**STATE OF TENNESSEE  
DEPARTMENT OF TRANSPORTATION  
DESIGN DIVISION**

**INSTRUCTIONAL BULLETIN NO. 13-08**

**Regarding New and Revised Standard Drawings**

**Effective for the July 12<sup>th</sup> letting (May 1<sup>st</sup> turn-in),** the following Standard Drawings are new or revised and Section V of the Design Guidelines is revised for this update.

**DESIGN STANDARDS FOR SINGLE LANE URBAN AND RURAL ROUNDABOUTS**

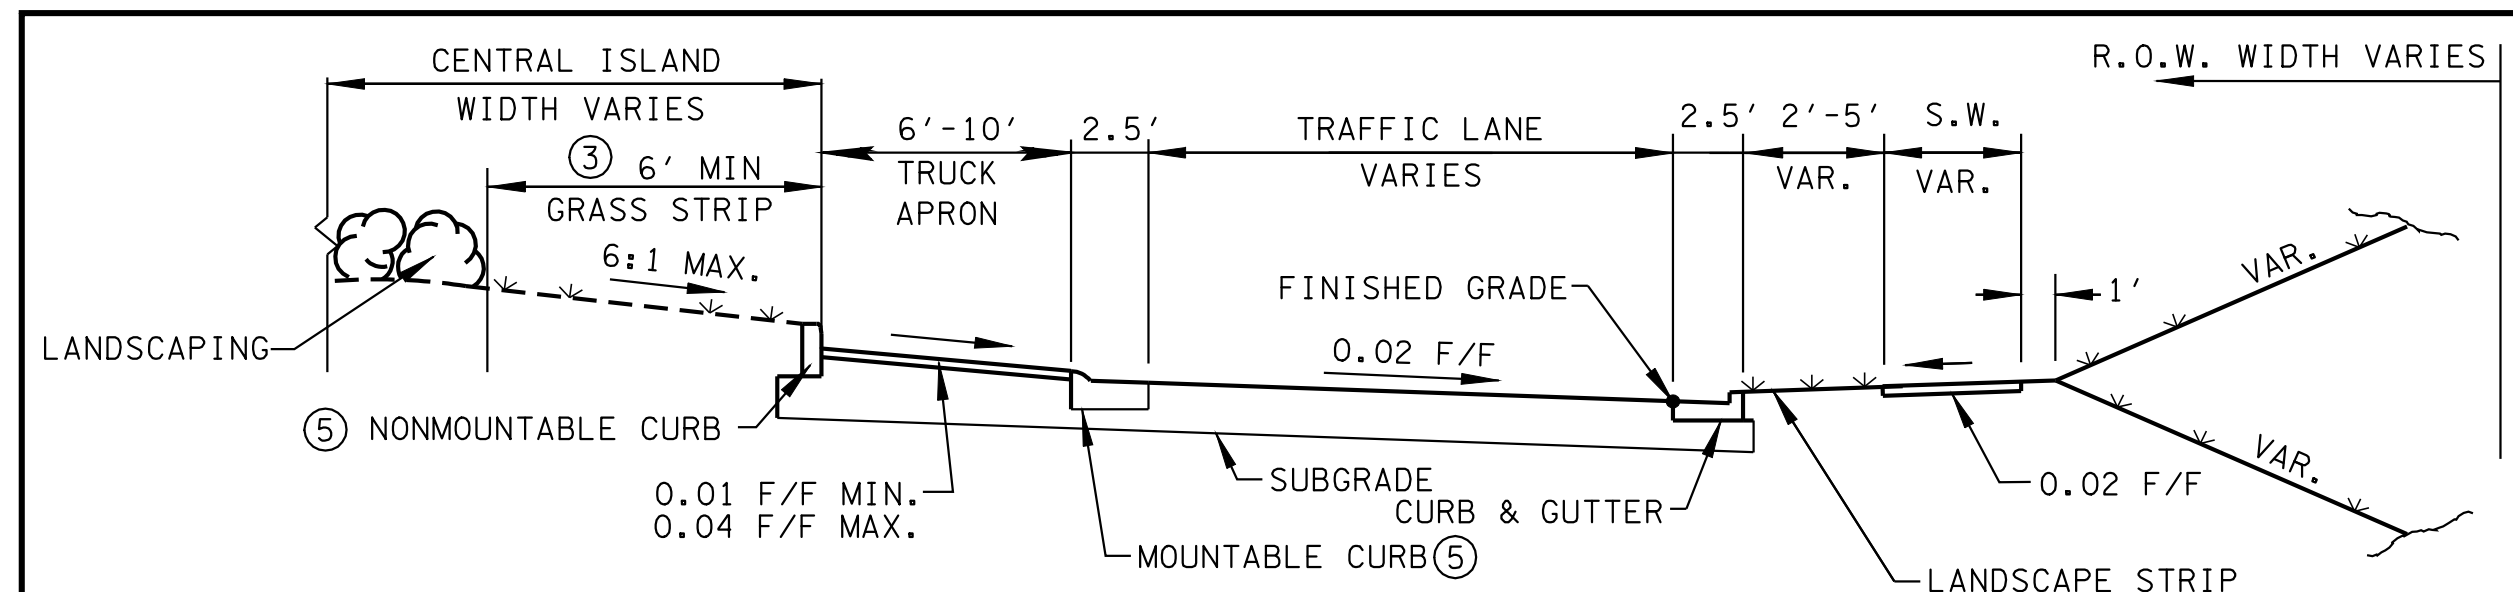
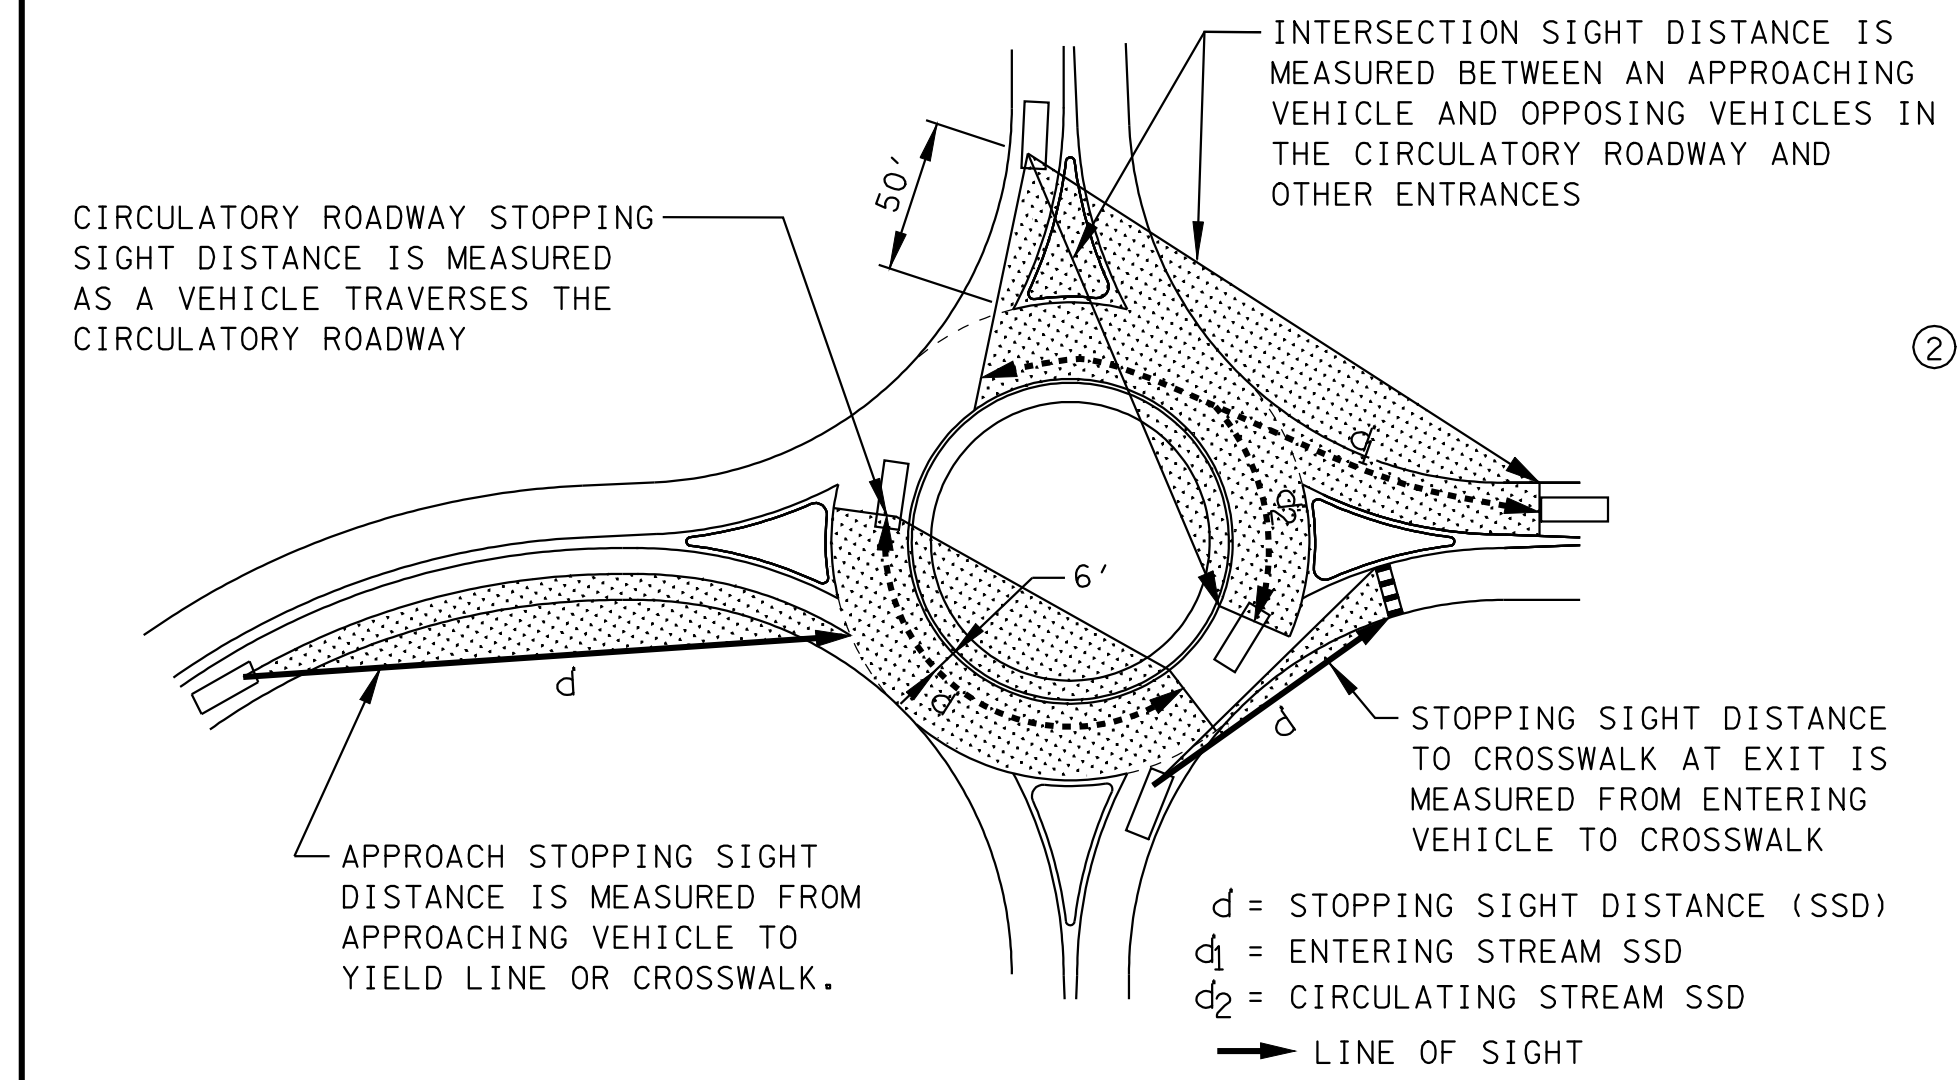
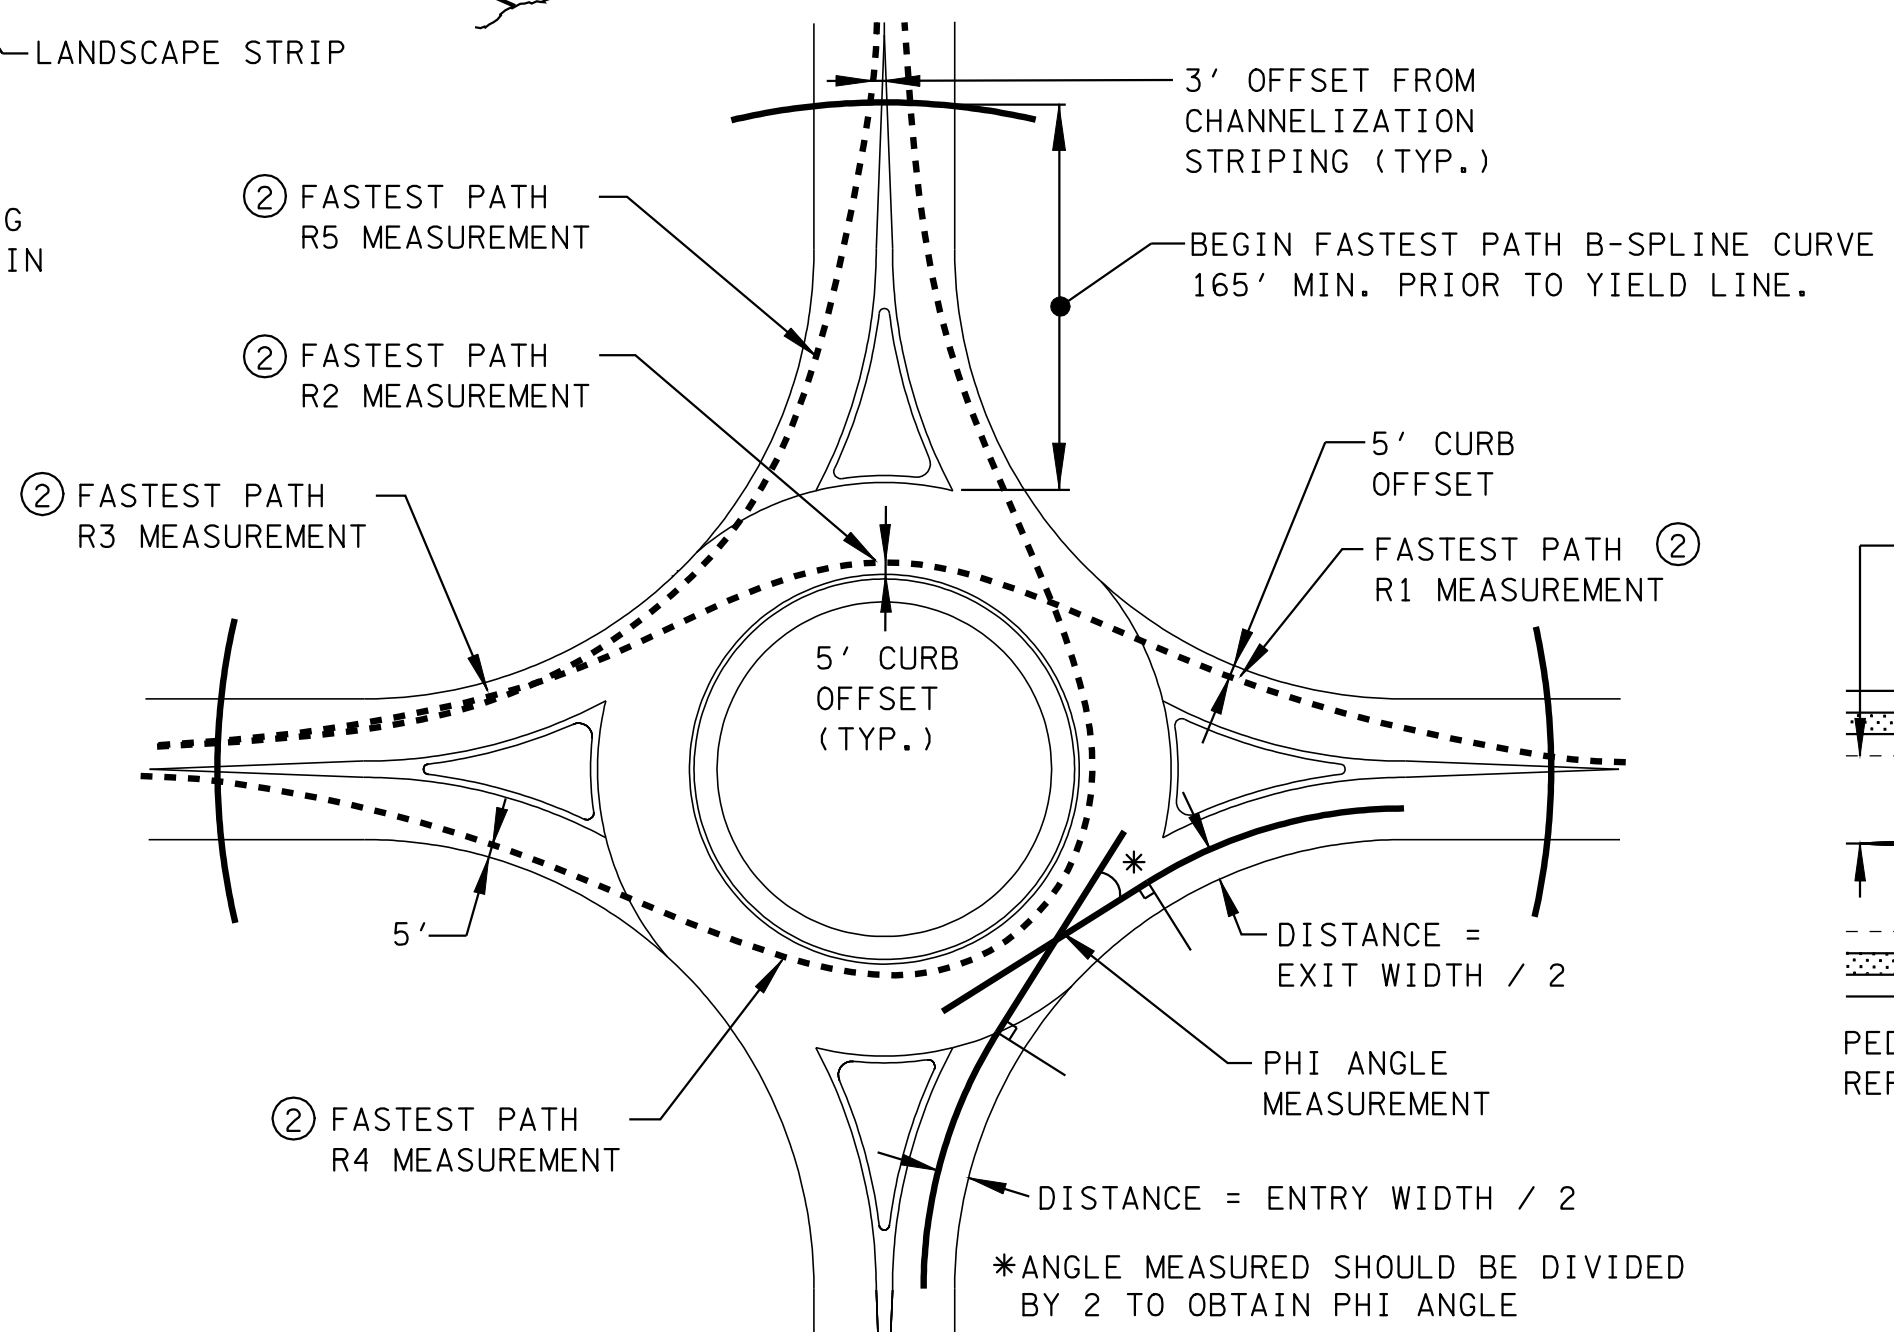
REV. 2-1-12: ADDED OPTIONAL PEDESTRIAN RAIL.  
 REV. 6-15-12: RENAMED SHEET FROM RD-TS-9. ADDED NOTE (M)
